Delegated Report		Analysis sheet		Expiry Date:	30/09/2021
(Members Briefing)		N/A / attached		Consultation Expiry Date:	24/10/2021
Officer			Application Number(s)		
Obote Hope			2021/3790/P		
Application Address			Drawing Numbers		
16 Millfield Lane London N6 6JD			Refer to decision notice		
PO 3/4	Area Team Signature	C&UD	Authorised Officer Signature		
Proposal(s)					
Demolition and replacement of boundary treatment adjacent to the highway, new landscaping arrangement including the removal of 9 trees; addition of a new front porch, installation of solar panels and replacement refuse store and minor changes to the front fenestration.					
Recommendation(s):		Grant Full Planning Permission			
Application Type:		Householder Application

Image 1. Existing front elevation

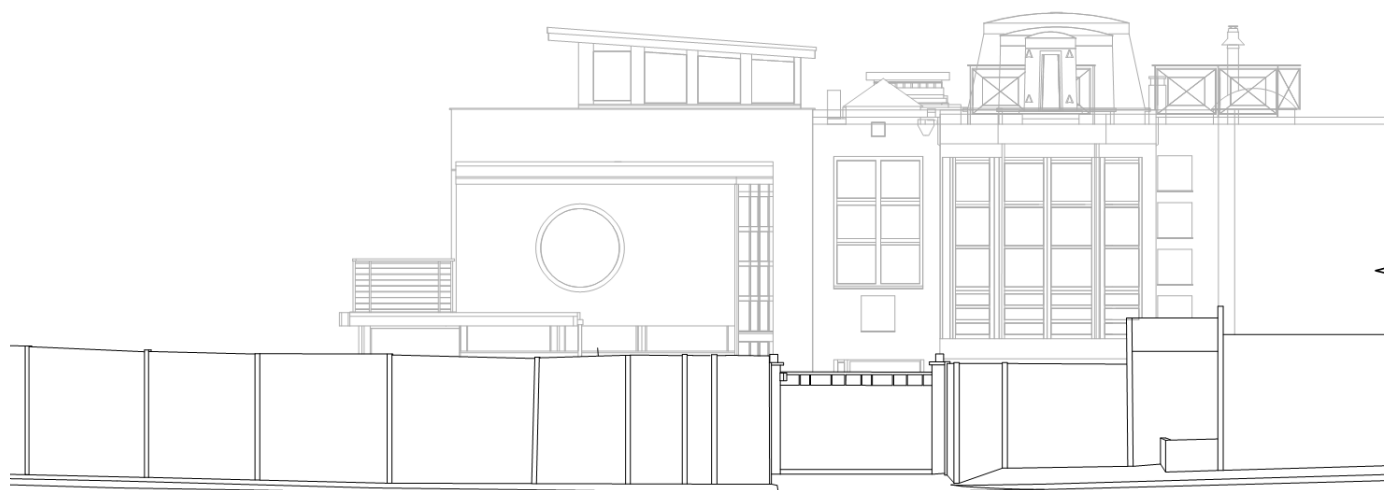
3.2 There is a section of the front boundary wall that is in disrepair. It is proposed to replace the existing timber fencing with a low rise London yellow brick wall topped with a timber fence. Whilst the new fence and gate would be higher, the boundary treatment matches the height of both of the neighbouring boundaries to the north and east and steps down in height around the corner of Millfield Land to reflect the change in topography and is considered in keeping with the character of the street. The height of the altered boundary wall would match the neighbours and in this instance preserves, or even moderately enhances, the conservation area. Overall, the proposed boundary treatment would be an improvement on the poor condition of the existing boundary wall and the matching brickwork would not detract from the design and appearance of the surrounding area.

Image 2. Revised proposed front elevation.

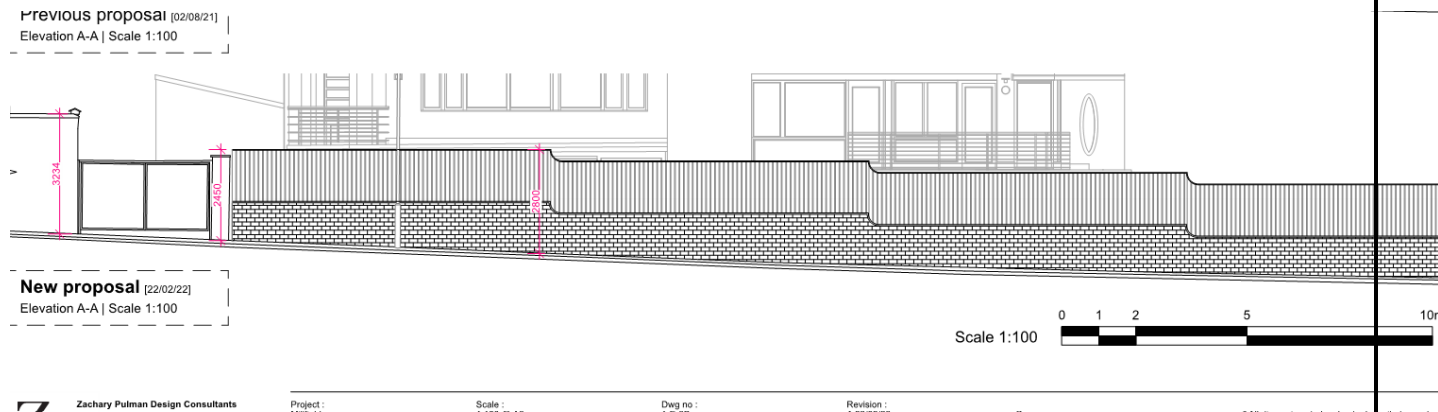
- The height of the boundary wall has been reduced from 3.1 - 3.7m to between 2.8 to 3.1m in height

3.3 The creation of a glazed front porch to the northeast elevation is considered appropriate in this unusual instance. The use of glazing for the porch is considered to be acceptable as it would match the existing glazed doors to the front elevation of this property. The porch would not be immediately prominent from the public domain by virtue of its boundary treatment and distance from the public domain.

3.4 The removal of the two timber sheds and construction of 4 replacements with two sheds of a slightly larger size is considered acceptable in design terms. Whilst, the two additional sheds would have a larger footprint, the additional stores would not add excessive bulk to this part of the site. The proposed work would not detract from the character and appearance of the conservation area and on balance would be acceptable in design terms. Moreover, the proposed concrete structure of the proposed external stores would be set below the side boundary walls, therefore the works would be screened from immediate public views.
